**CLINCH RIVER
BREEDER REACTOR PROJECT**

**PRELIMINARY
SAFETY ANALYSIS
REPORT**

PROJECT MANAGEMENT CORPORATION

Figure Q001.451-8 Steady-State Fission Gas Retention for the Q001.451

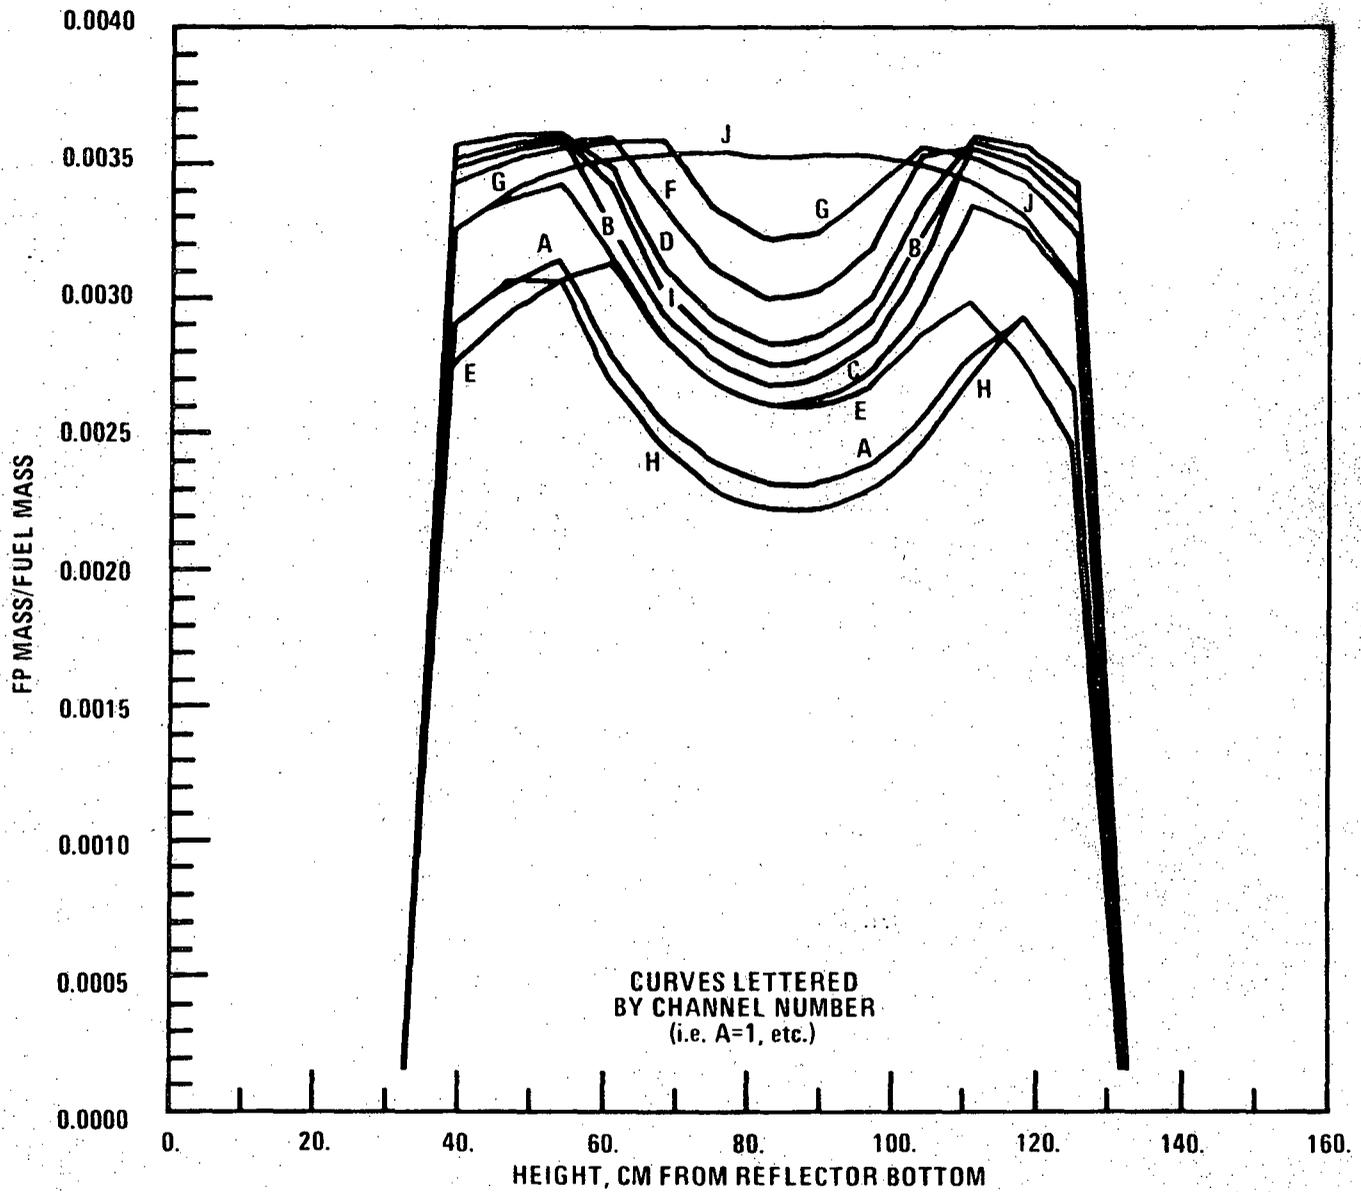
Question 001.451 (F6.2.3.4.3)

- a) Early failures might be beneficial to the outcome of the accident;
- b) Assuming use of the burst failure criterion, the more restructuring, the higher the pin is likely to fail;
- c) The more restructuring, the less transient fission gas is available for pressurization;
- d) The unrealistic stimulation of early failures may introduce incoherence which would make the outcome non-conservative;
- e) Fuel-pellet clad contact (i.e., zero gap) may enhance local boiling and/or local secondary loading failures.

- (c) Figure Q001.451-8 and Figure 5-22 of Ref. 15, PSAR Section 1.6, compare the steady-state fission gas retention. There is obviously more fission gas available with the lower steady-state fuel temperatures. As pointed out above, this results in pin failure with a smaller amount of molten fuel. With more restructuring, more fuel must melt to get sufficient pressurization for pin failure. The base case had 45.4 gm of molten fuel in the pin cavity at failure; the high gap conductance parametric had 23.6 gm. In a slow TOP accident, less transient fission gas availability is a conservative assumption. | 60 | 31

Figure Q001.466-1. Variation In F/A #6 Hot Channel Temperatures For Control Assembly Withdrawal At Power With Shutdown System Failure

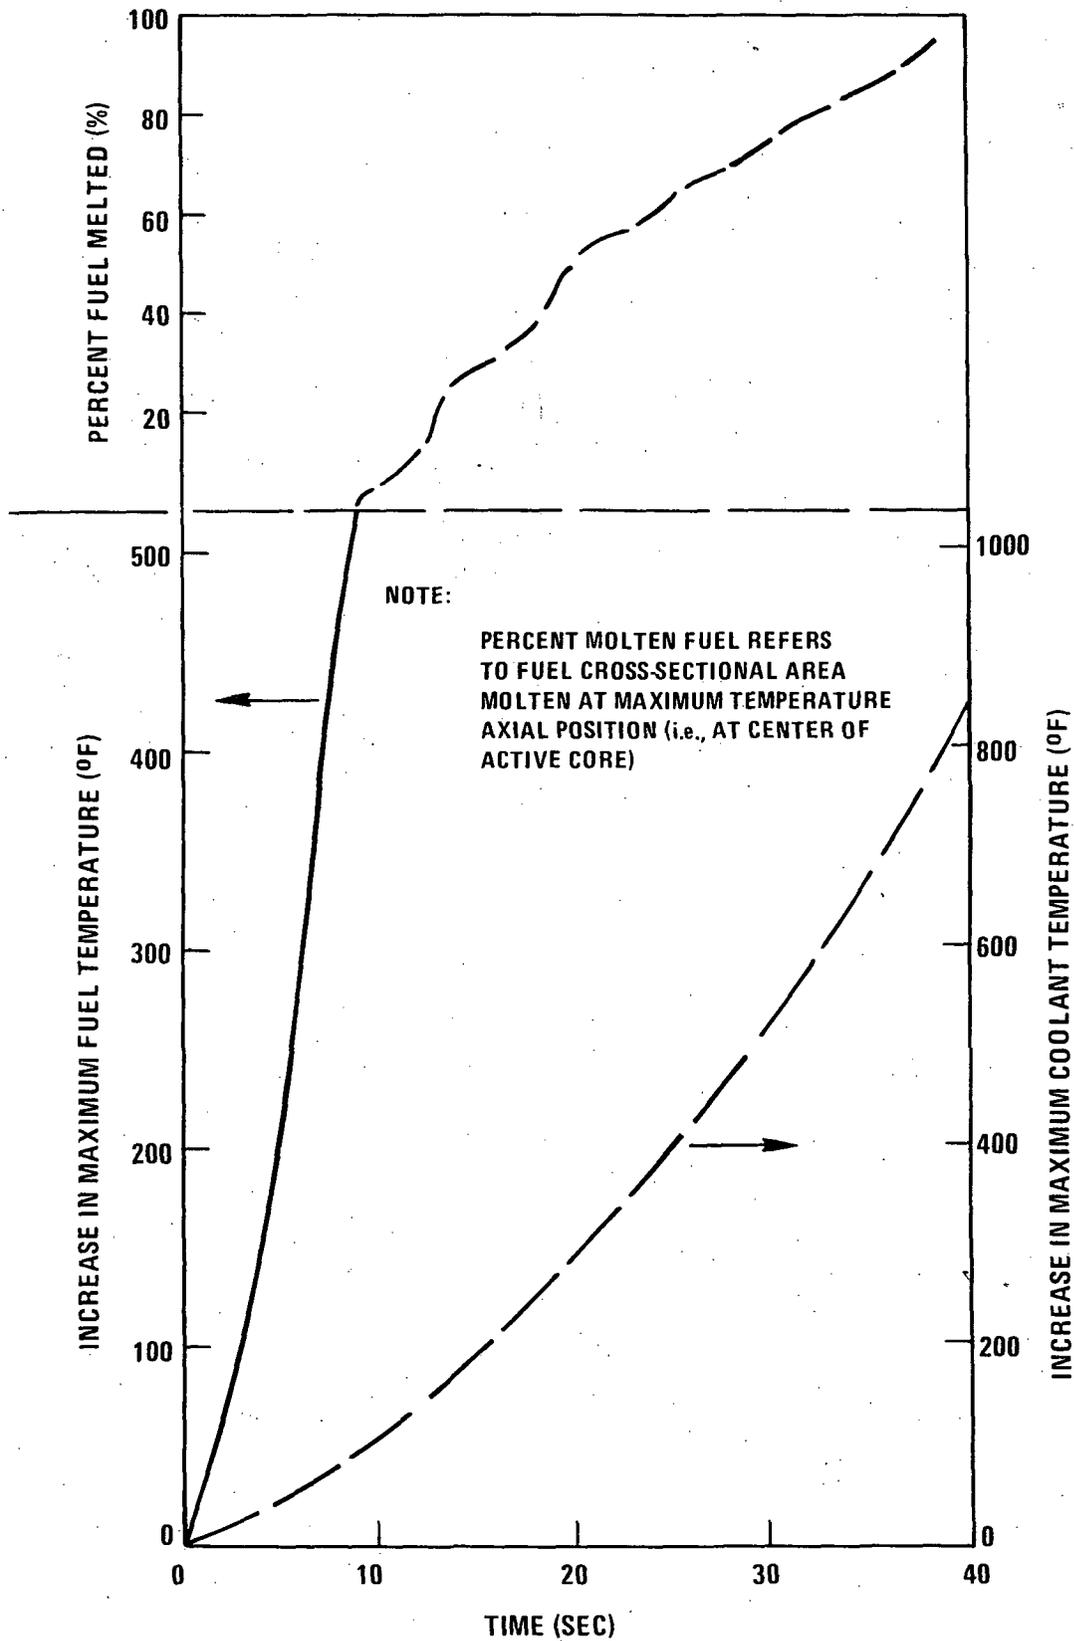
Question 001.466 (F3.2.1.2)

Figure Q001.469-1 GAP Conductance (Channel 2)

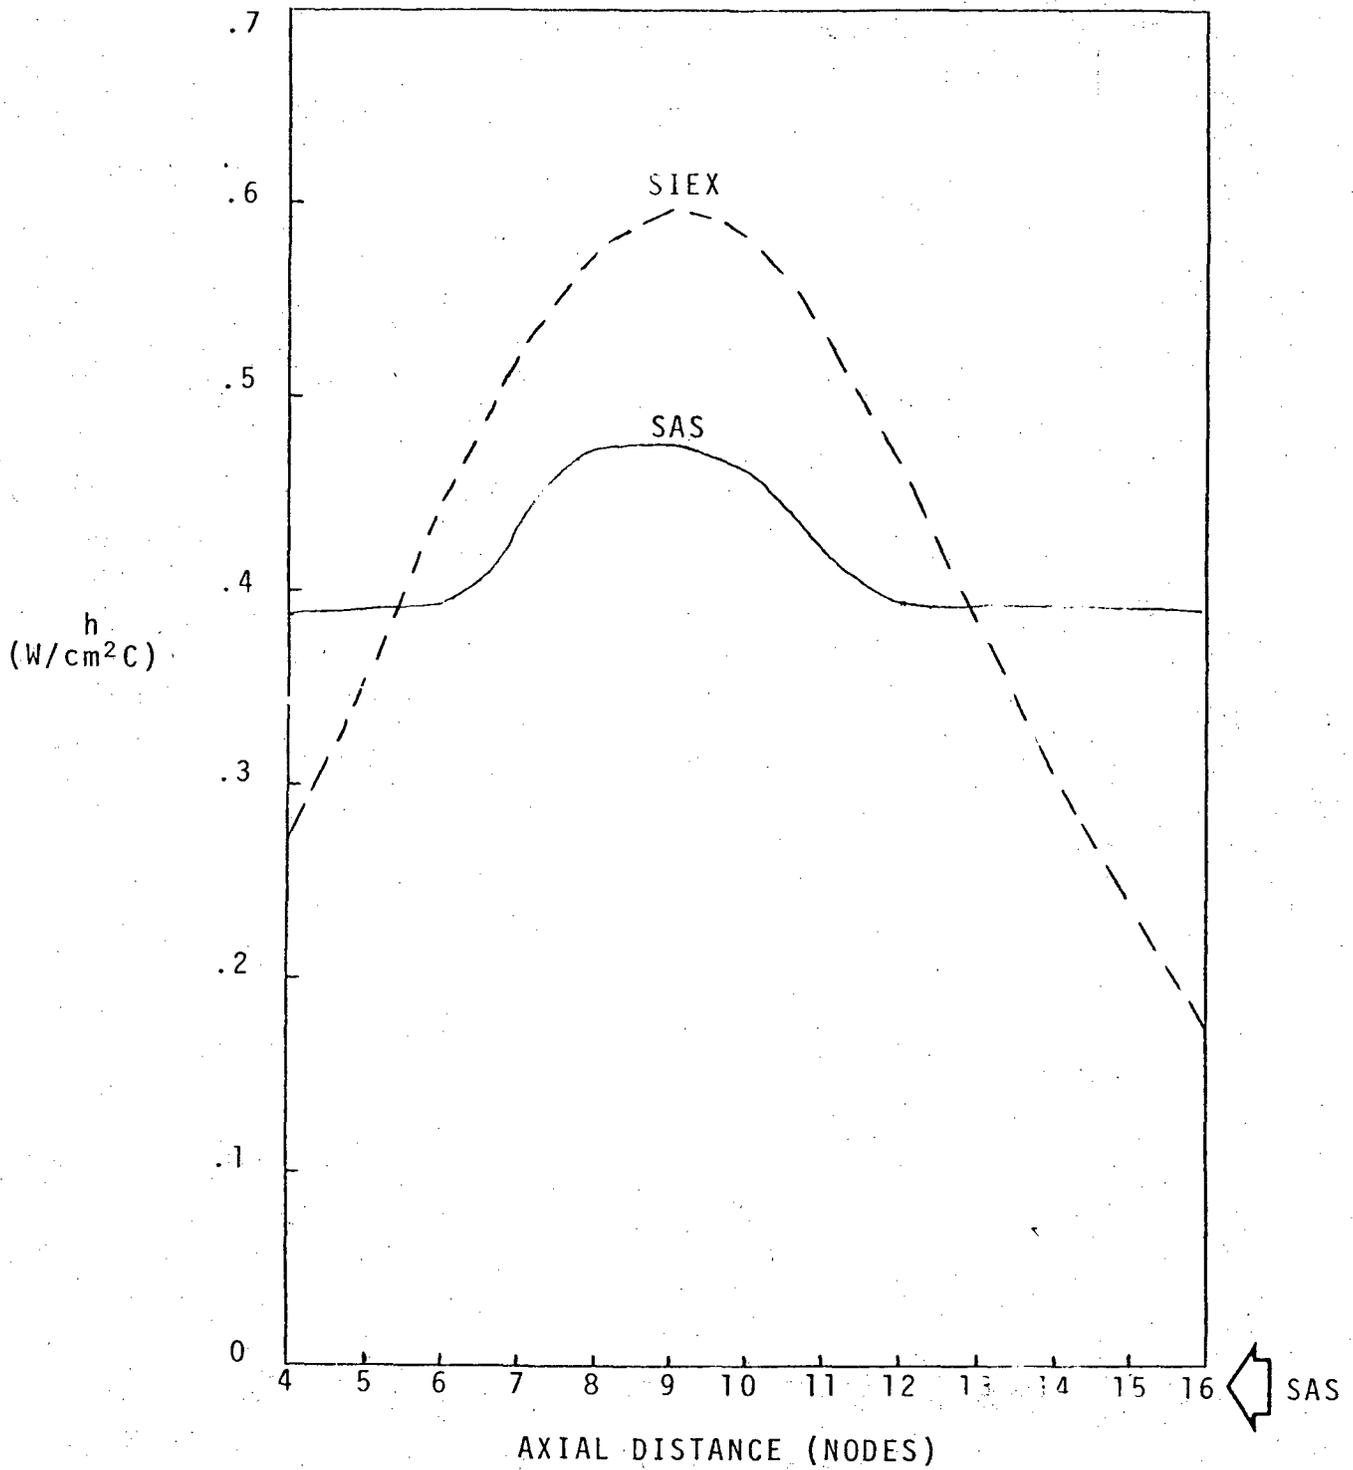
Question 001.469 (F6.2.3.3)

The primary reason for the differences between the SAS and SIEX calculated values of the parameters in Figure Q001.469-2 to 4 is the difference in gap conductance, shown in Figure Q001.469-1.

Figure Q001.487-1 ACCURACY OF POINT KINETICS REACTIVITY
IN A CRBR EEC LOF TRANSIENT

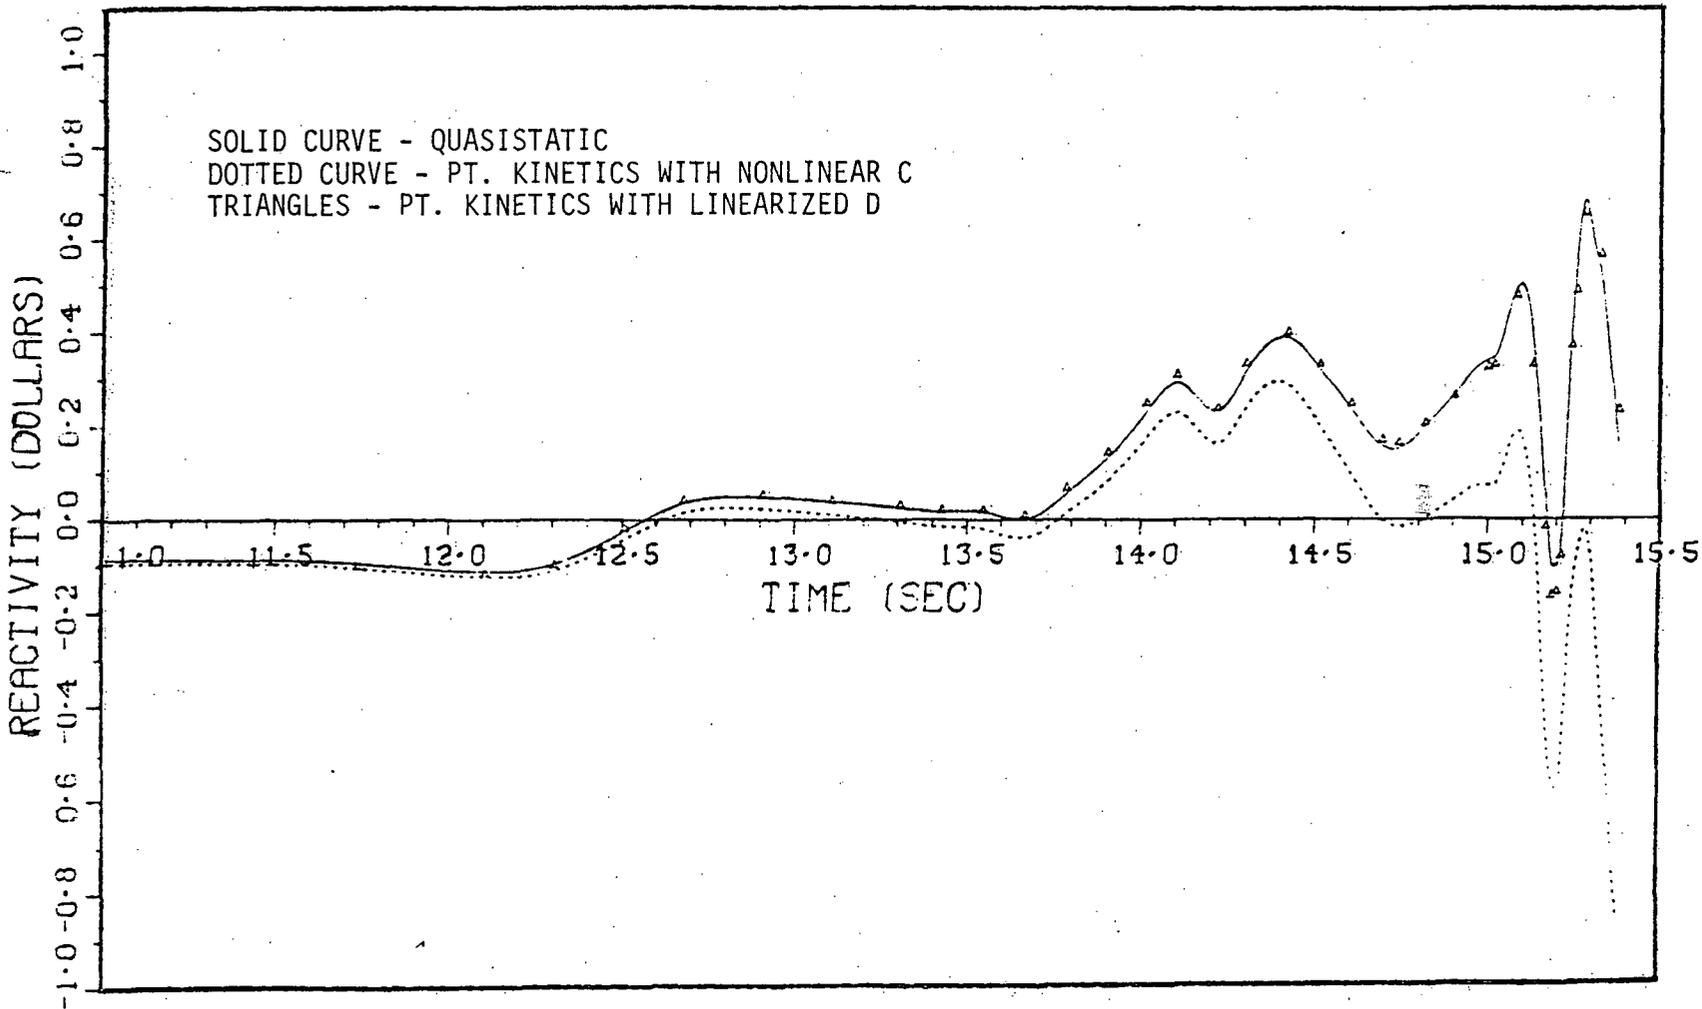
Question 001.487 (F6.2.4.1.3)

Figure Q001.539-1

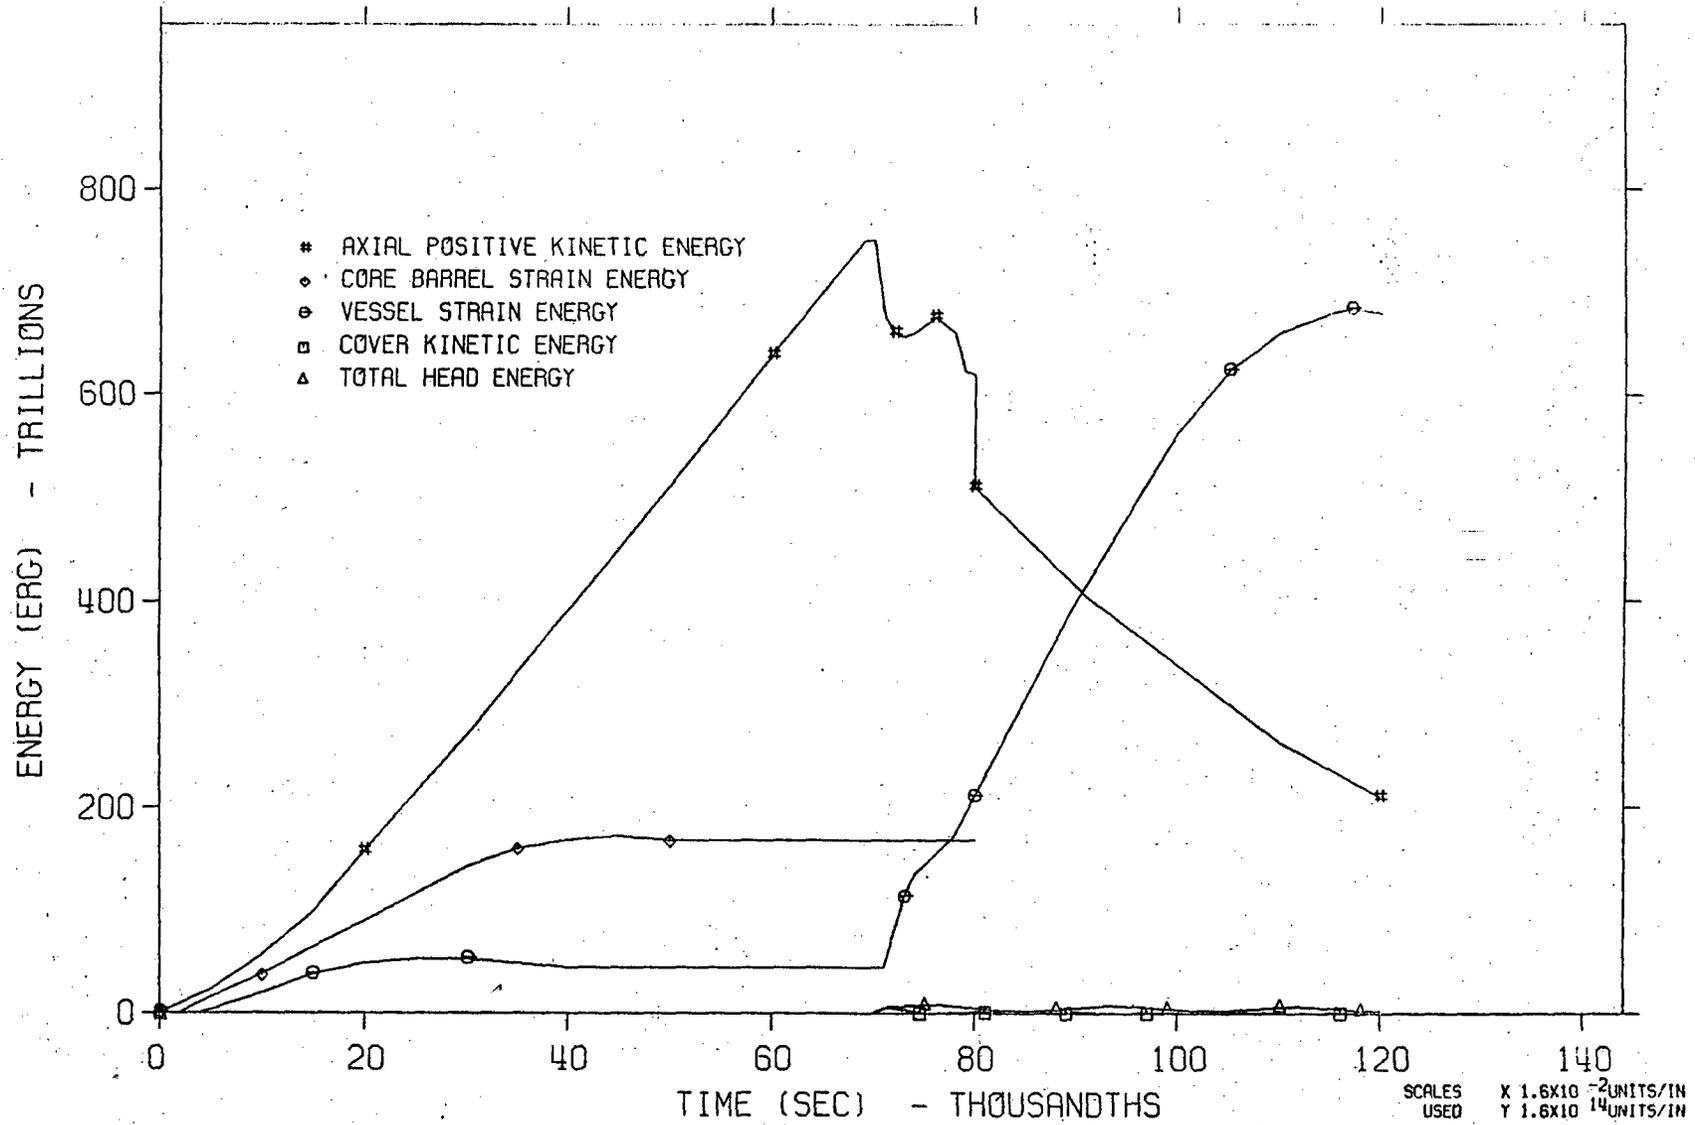
Question 001.539 (F6.3.2.3)

The energy partition curves as a function of time are presented in Figure Q001.539-1 and Figure Q001.539-2. Figure Q001.539-1 contains the energy curves of axial positive kinetic energy (sodium slug), core barrel strain energy, vessel strain energy, head kinetic energy (rotating plugs) and total head energy. Since the rotating plugs are modeled as a rigid body in REXCO analysis, the difference between the total head energy and head kinetic energy will be the strain energy of vessel holddown bolts. The support ledge is modeled as a rigid foundation in REXCO, therefore there is no strain energy associated with it. The core support is modelled as a flat thick plate. The energy curve associated with this model is not provided here because the model is not considered as representative to provide the strain energy of the support. (The purpose of the model is to reflect a conservative load on the core support.) Figure Q001.539-2 is an enlarged version of head kinetic energy and total head energy.
